City of Alachua

Planning & Community Development Department Staff Report

SUBJECT: A request for a Site Plan for the construction of two (2) buildings, a ±23,439 square foot building and a ±26,682 square foot building, with associated drainage, paving, grading and infrastructure improvements

RE: Planning & Zoning Board (PZB) Public Hearing: Upland Industrial Park Lots 2 – 5 Site Plan

Additional Comments Based Upon 8/9/2018 Plans

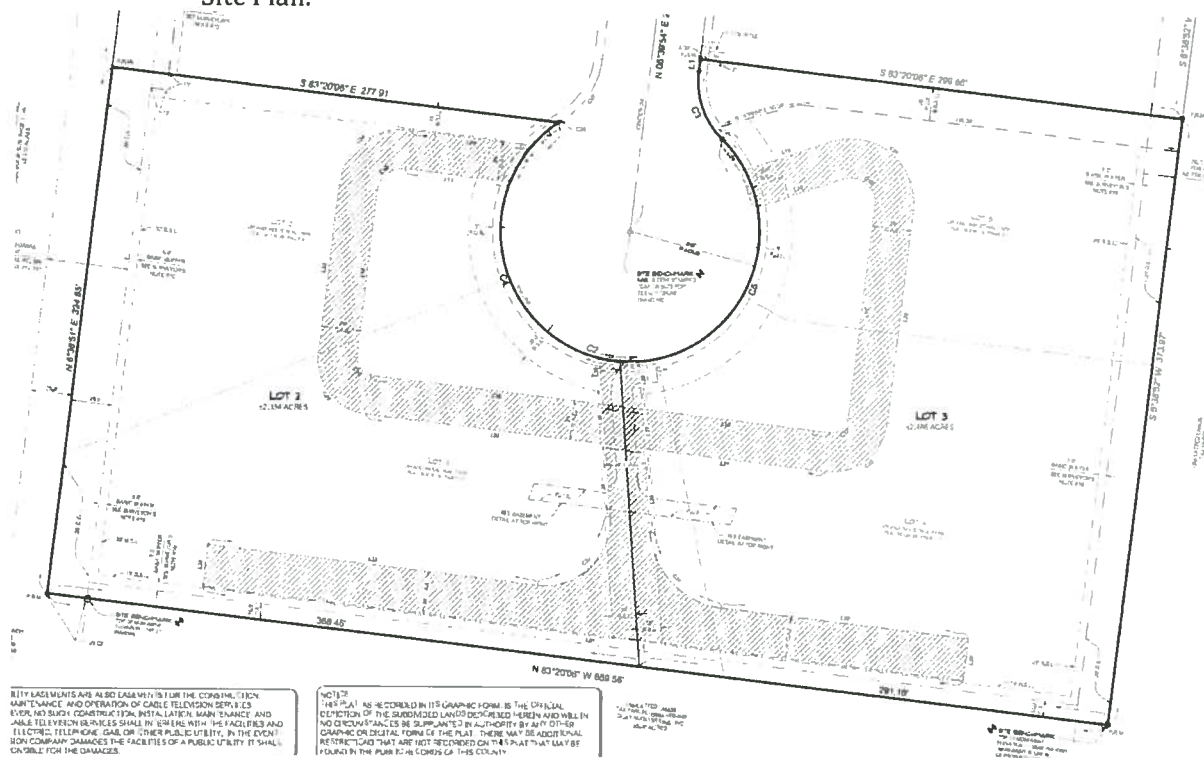
5. Sheet C1.20: Correct the location of ADA accessible path / sidewalk from ROW to building on Lots 4 – 5.

Remaining Issues: ADA accessible path and sidewalk are do not align. Revise accordingly

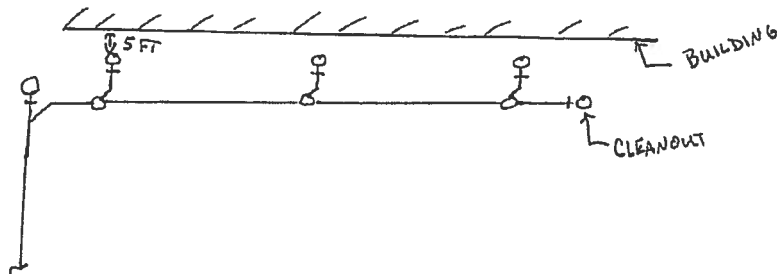
10. In the north east corner, there is a contour with both a 123 label and a 124 label. Correct the label.
11. Is the purpose of the existing inlet in the north west corner of the property to capture the discharge from offsite? Verify that the swale directs water to the inlet and that the inlet can accommodate the runoff from the swale.

12. Provide cross sections of the driveway connections to demonstrate grading and handicap accessibility of the crosswalk. The driveways appear steep.

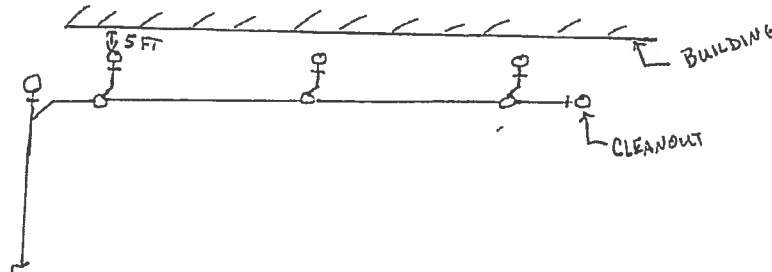
10. In the north east corner, there is a contour with both a 123 label and a 124 label. Correct the label.
11. Is the purpose of the existing inlet in the north west corner of the property to capture the discharge from offsite? Verify that the swale directs water to the inlet and that the inlet can accommodate the runoff from the swale.

12. Provide cross sections of the driveway connections to demonstrate grading and handicap accessibility of the crosswalk. The driveways appear steep.

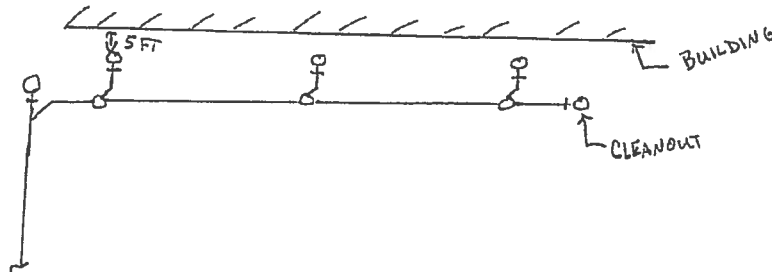
10. In the north east corner, there is a contour with both a 123 label and a 124 label. Correct the label.
11. Is the purpose of the existing inlet in the north west corner of the property to capture the discharge from offsite? Verify that the swale directs water to the inlet and that the inlet can accommodate the runoff from the swale.

12. Provide cross sections of the driveway connections to demonstrate grading and handicap accessibility of the crosswalk. The driveways appear steep.
